10-F-23-HZ
APPLICATION FOR CERTIFICATE OF APPROPRIATENESS

1800 Clinch Ave. 37916
Ft. Sanders NC

Original Print Date: 10/4/2023
Knoxville/Knox County Planning -- Historic Zoning Commission

After-the-fact review of exterior rehabilitation elements which do not align with Historic Zoning Commission review and issued COA (1-D-23-HZ). Changes during construction include the below.

FIRE SEPARATION DIAGRAMS

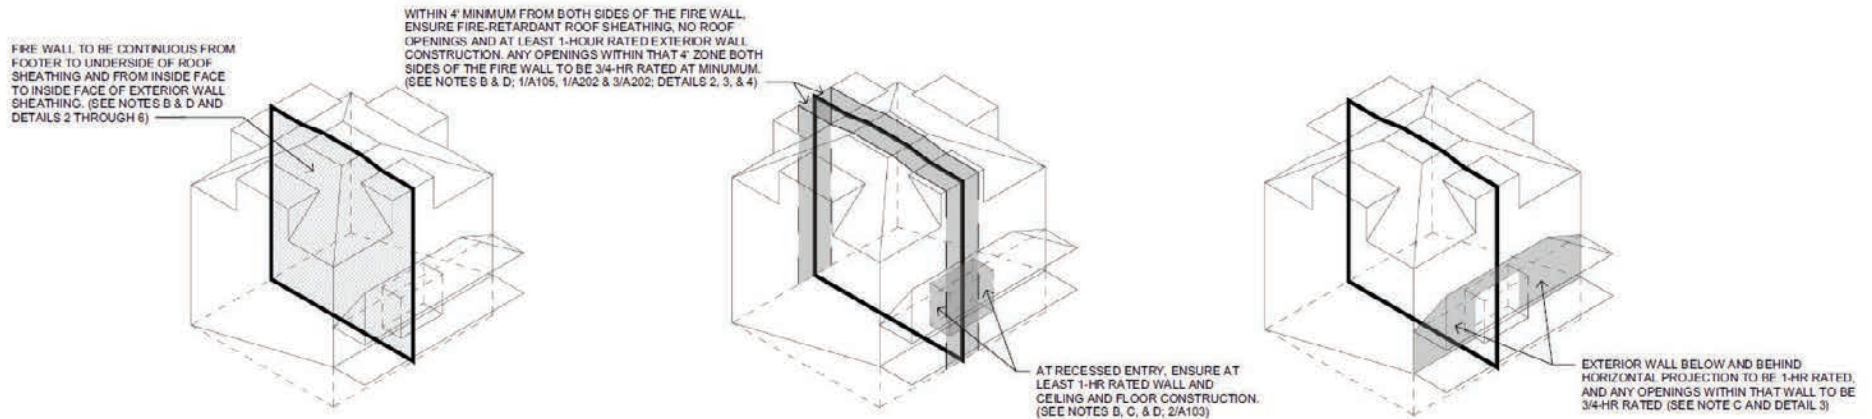
The existing building was cut entirely in half in order to create a code compliant firewall between the dwelling units. Without this, one or two large fire staircases would be required on opposite ends of the building.

If the firewall doesn't extend beyond the outside walls, openings within 4' of this wall are required to be fire rated.

**CHANGE #1 - DORMER WINDOWS BACKED WITH
FIRE RATED MATERIAL**

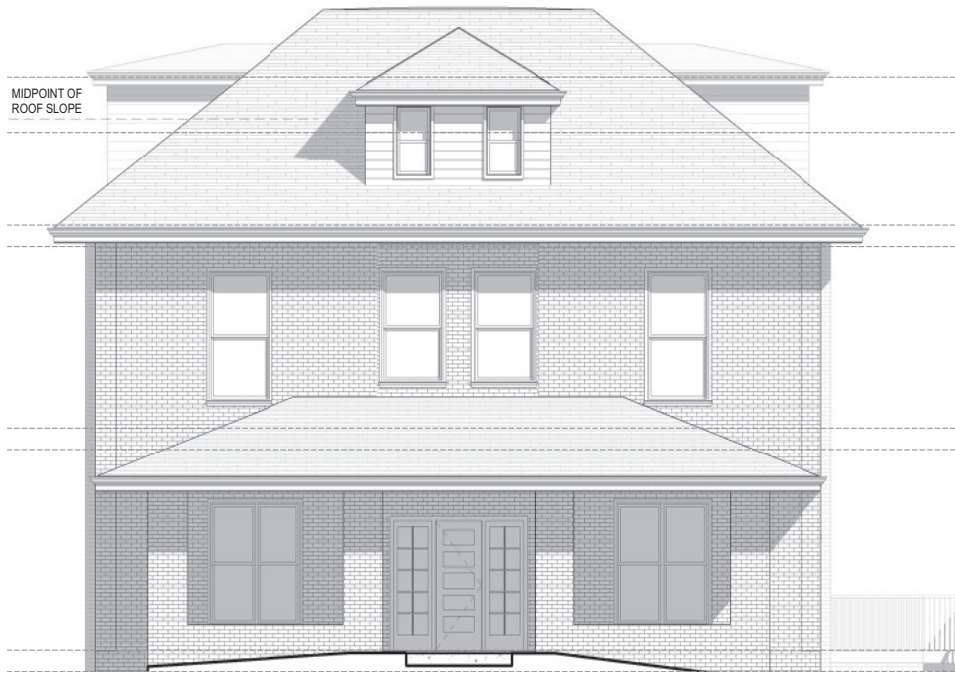
- On the dormer, windows have been enclosed from the inside with black-painted, fire-resistant backing. Photos provided indicate two pairs of sliding or casement windows on the new right side dormer (left side dormer not shown); approved drawings indicated three double-hung windows.

3. Front dormer modifications: the HZC would not typically review interior modifications to apply backing to a window. The backing could be removed should the applicants invest in fire-rated windows for the dormers. The darker color behind the dormers is generally not visible from the street and could be construed as blinds.

NEW WINDOWS W/ OPAQUE, FIRE RESISTANT BACKING.
(TRIM AND SIDING NOT PAINTED AT TIME OF PHOTOGRAPH)

The firewall is required to extend to the roof. Per IBC 706.5.1, openings within 4' of a firewall that is not extending beyond the exterior walls, but have a fire rating of 3/4 hour.

After it became clear that the windows installed were not fire rated, most viable solution was determined to be closing the windows from inside with fire protection, but leaving them in the wall.

The fire protection was painted black so that from the outside it isn't clear that the windows are covered from inside.

This may be within compliance of the guidelines, however, inspections noted to get approval from the board.

Staff recommends after-the-fact approval of the projecting entry vestibule, the fire-rated covering on the front

CHANGE #2 - 2ND STORY WINDOWS CHANGED TO GLASS BLOCK

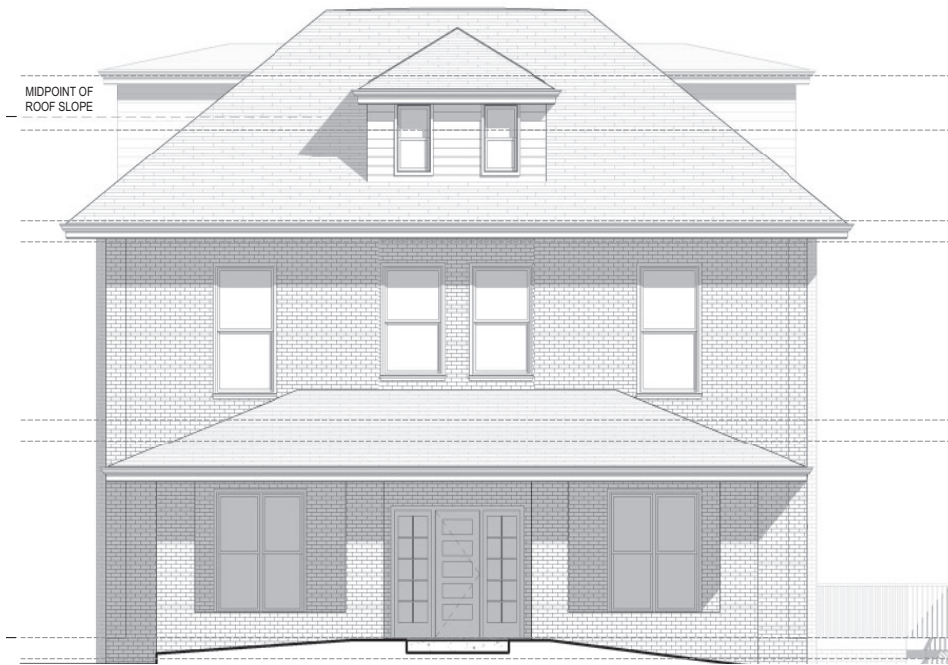
- On the center bays of the second story, glass block windows were installed instead of one-over-one, double-hung windows as proposed. The glass block windows also appear to be extended in height from the drawings, with the bottoms of the windows resting on the porch roof instead of separated by sills and 1-2 courses of brick as shown.

5. Second-story center windows: the glass block windows and window size is inappropriate for the building's design and does not reflect the approved COA. The applicant should select double-hung, one-over-one windows which are compatible with the remaining double-hung windows on the building and revise the window heights to reflect the proposed drawings, be the same overall size and placement as the windows on the second-story outer bays, and include sills as initially submitted.

Double hung windows were installed, but were discovered during final inspection to not be in compliance with 706.5.1.

A request was made to the window supplier to provide fire rated windows and the construction team was told that would not be possible.

At 2 weeks into the semester, and with the student tenants needing to move in, the construction team determined they had two options for compliance with a timely completion:

Either replace with the windows with glass block, or board up the windows from inside like they did for the third floor. Due to the size and amount of daylight they provide, boarding up the windows from inside would have a very negative effect on for the users, so they installed the glass block.

CHANGED/BUILT CONDITION, GLASS BLOCK USED IN 2ND STORY WINDOWS

Staff recommends denial of the glass block design in the second-story center windows, the new front doors, and the change in side dormer window design and number. Applicant should select double-hung windows to replace the glass block infill, revising the fenestration opening to match the original COA and the size of adjacent windows, with a revised drawing submitted to staff for approval; select new entry doors meeting the design guidelines and submit to staff for approval; and revise the side dormer windows to reflect the original COA (three double-hung windows), with a revised drawing submitted to staff for approval.

1. RATED WINDOWS

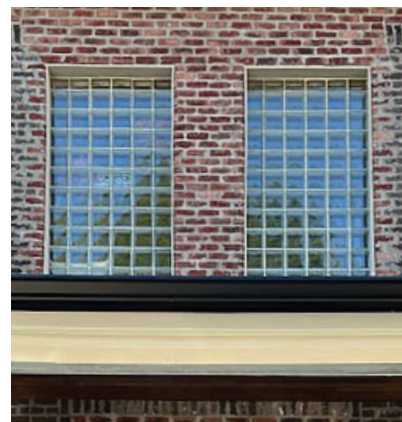
In the process of trying to find a solution for compliance, the development team realized that with more time, they have the following options for their 4' wide x 7' tall windows:

Option 1 - Fire rated double hung windows. They discovered that these are incredibly difficult to get. There are companies that provide them, but they are custom and rare, making them have with high cost and long lead times (especially at this size.) They have a bulkier look to them than the windows installed, and the glass tends to be a different shade.

Option 2 - "Storefront" Windows The more viable option locally for fire rated windows is using a storefront system, with the glass being placed in an aluminum frame. These also have a bulkier look than the windows installed.

Option 3 - Fire Shutters These are small overhead doors that come down in the event of a fire. They too have very long lead times.

Option 4 - Glass block Glass block is a historic material, older than the building in question. The grid that it creates, is somewhat similar proportionally to those of square historic window panes.

We believe that if we are going to have a unique look in the middle two windows, it would be better if they are intentionally different than the other windows, (instead of slightly different) while still being historically accurate to how this problem would have been resolved when this structure was built in 1917. For that reason, our request is to approve the glass block.

CHANGED/BUILT CONDITION

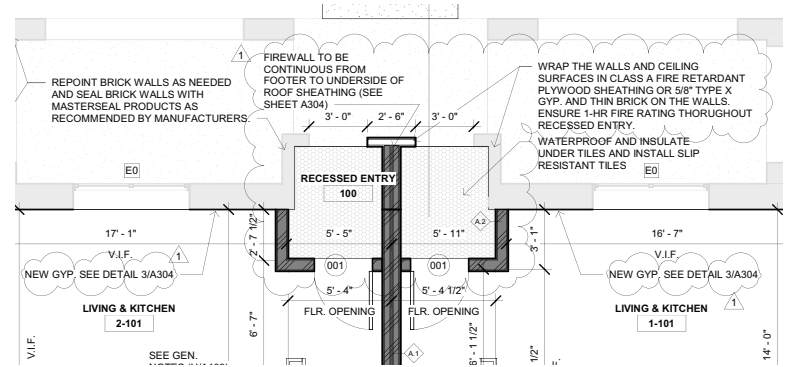
- A projecting entry vestibule was constructed, with doors recessed from the primary façade. The approved elevation drawing depicted two multi-light exterior doors flanking a wood panel, flush with the primary elevation, and centered on the façade. The doors are two six-panel metal doors separated by a brick wall.
-

6. Entryway: The new entry vestibule somewhat reflects the engaged brick pilasters which used to flank the front door. The new entry vestibule differs from the approved designs, but does not detract from the overall building's design. New entry doors are recommended to have "similar proportions and features to pre-1940 architecture." The applicant should submit new entry doors meeting the design guidelines to staff for approval.

The original intent of the design was to maintain the look of a single entry door with two sidelights.

After the architecture team realized that IBC 706 would not allow this, the design was altered so that the sidelights became glass doors and there was a panel in the middle to reference the original entry door.

In the end, an overzealous mason decided that brick made more sense in the middle, and the availability of fire rated glass doors led to the entry doors being metal.

Unfortunately, there is no other alternative to having two separate entries for this building, so we request approval for the built condition.
